# UK Offshore Energy Strategic Environmental Assessment

Government response to OESEA4 public  
consultation

Figure 1: Carbon dioxide licensing; existing licences and licensing round offers

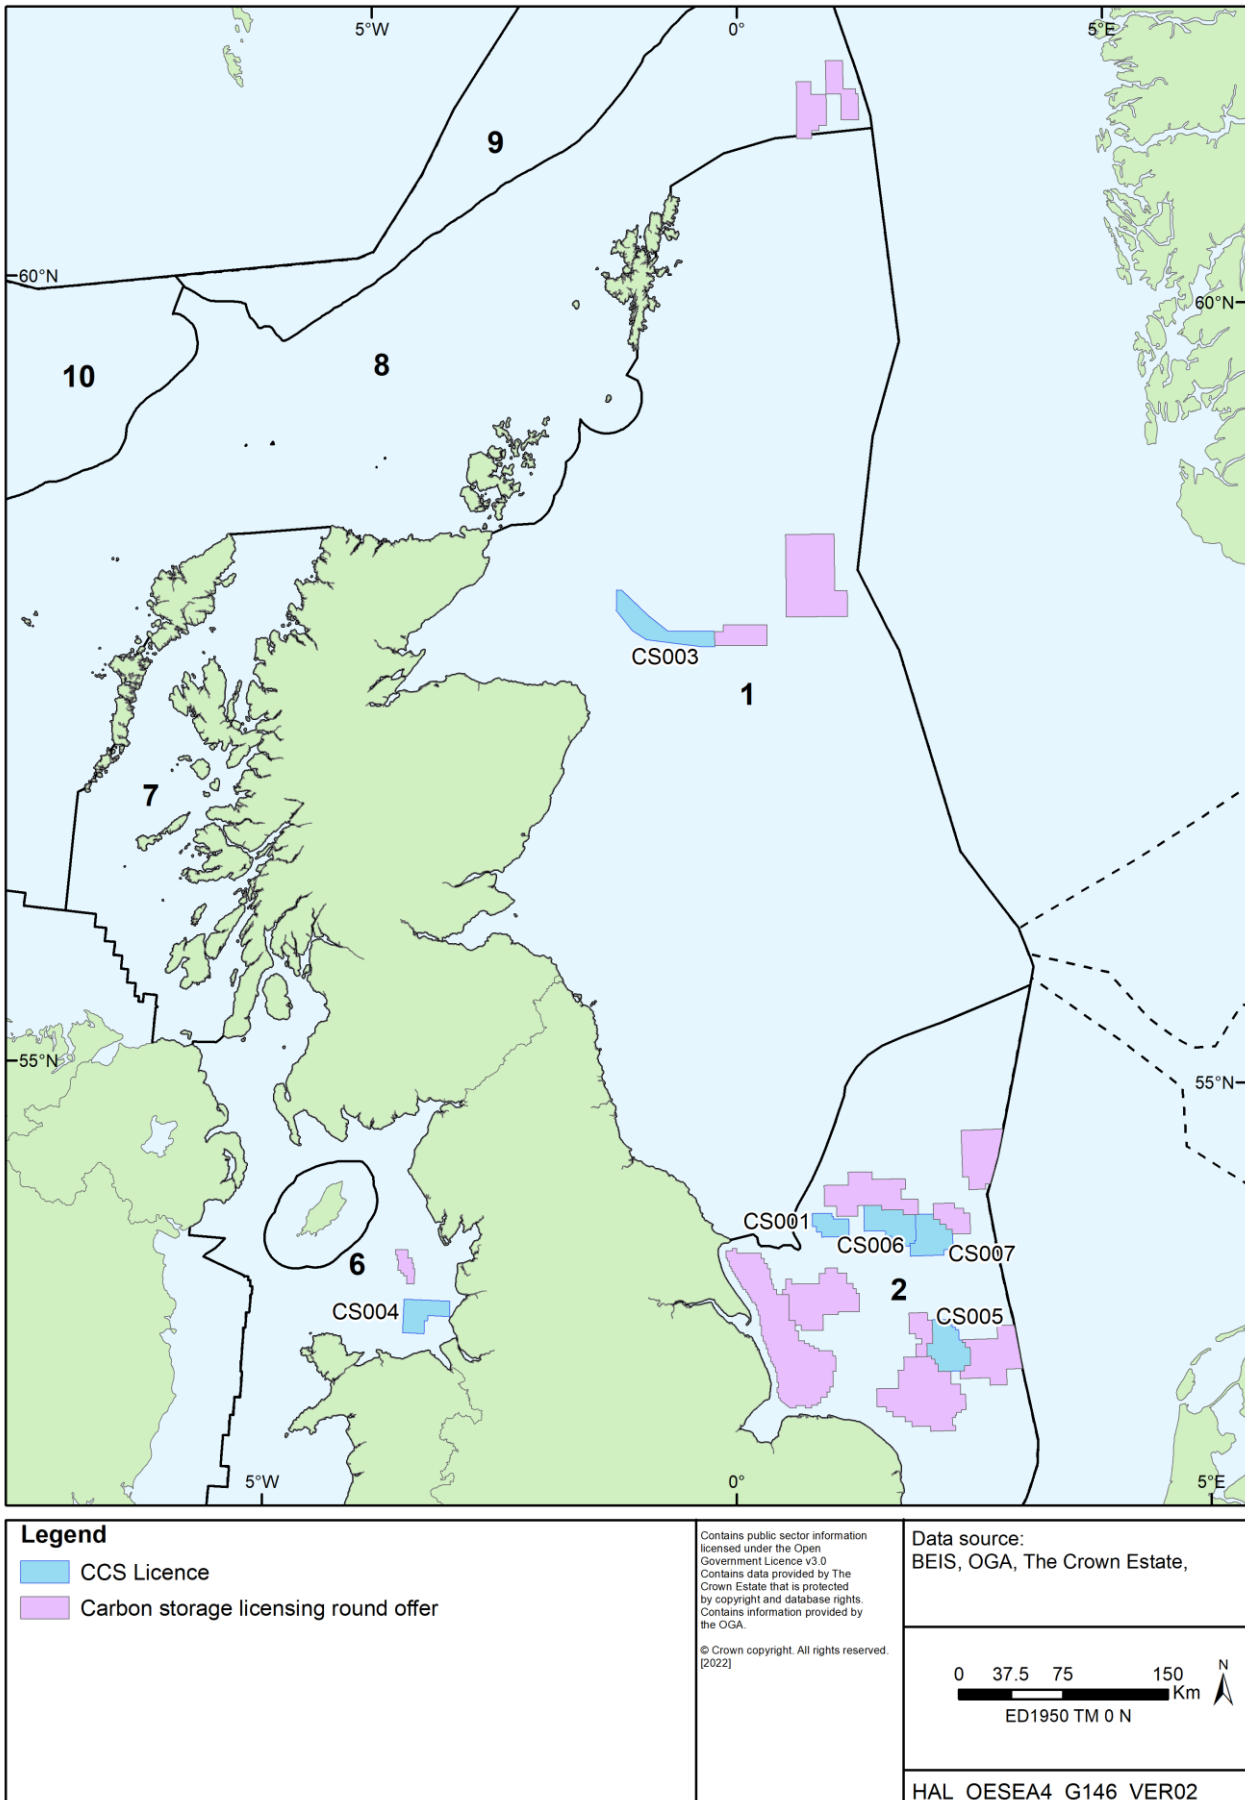
One respondent commented that maps in the ER lacked the latest carbon dioxide storage licensing position and also the wider areas of prospectivity for carbon dioxide storage. The latest carbon dioxide licensing position and the nominations for the carbon dioxide storage licensing round were not available at the time of publication of the ER, however, these have been mapped and are shown in Figure 1 below. With reference to locations on the UKCS where CCS is prospective, the CO<sub>2</sub>Stored database is referred to in Section 2.5.5 of the ER along with a general overview of the types and locations of prospective areas. Additionally, it was not considered to be practical to use the database in the overall spatial consideration (Section 5.15 of the ER and also see Section 2.13 below), nor was it considered appropriate to recommend a high level safeguarding for carbon dioxide storage sites given their wide geographical spread and high level of uncertainty at this stage as to which areas may be developed. At present, a level of safeguarding of carbon dioxide storage sites is provided by East Marine Plan Policy CCS2 (note that other marine plans for English waters and those of devolved administrations have no similar sector specific policy but do have more general co-location policies), and the current overarching National Policy Statement for Energy (EN-1)<sup>45</sup>, indicates that the Planning Inspectorate must “have regard to... any applicable Marine Plans in taking any decision”, noting that the NPS prevails over these plans in the event of any conflict between the documents.

storage sites (also see Figure 1), some of the licence areas and nominations were not available for use in the SEA at the time of publication and it was not considered appropriate or possible to consider all potentially prospective areas (e.g. after CO<sub>2</sub>Stored) within such a high level spatial analysis. While not making any inference about the potential for co-location, those carbon dioxide storage licence/lease areas available to include in the exercise were considered in a precautionary manner as hard constraints to other energy projects.
